Re: Rezone of 2208 Bellaire St.

This document is in response to the letter of opposition from Luann Erickson. She has concerns regarding the proposed rezone, to allow for an ADU on this property.

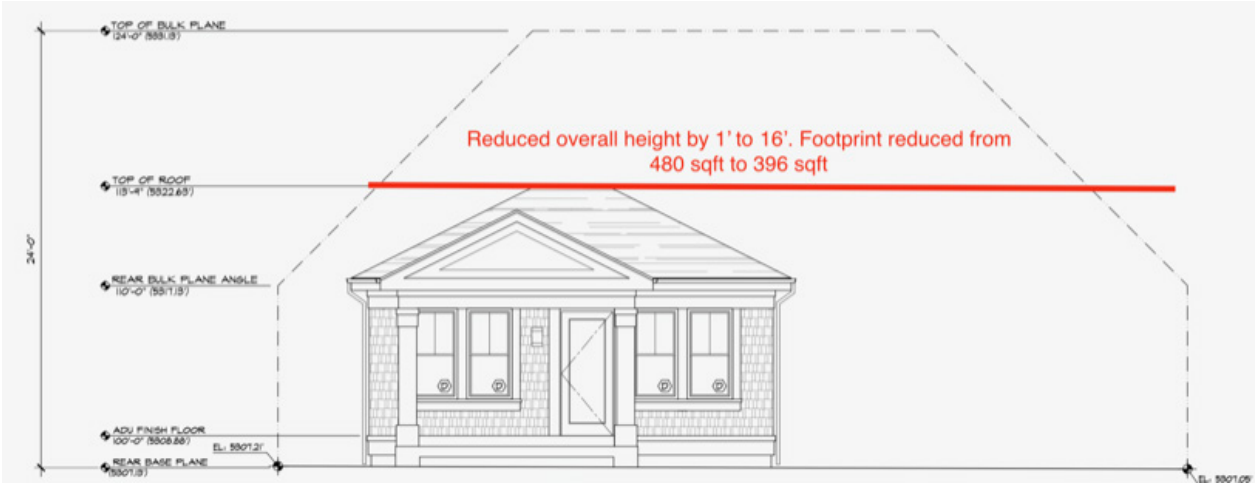
It was at this time (April 2021), that Molly and Andrew approached the neighbors to do some outreach. They showed the plans for this adorable little cottage. Two neighbors expressed concern over the proposed parking space next to the ADU. We eliminated this parking space in the next set of drawings to address this concern. Luann expressed more concerns, most of which were expressed in the letter you received.

In response to those concerns from Luann, we reduced the footprint from 480 sqft, to 396 sqft,

and reduced the height from 17' to 16'.
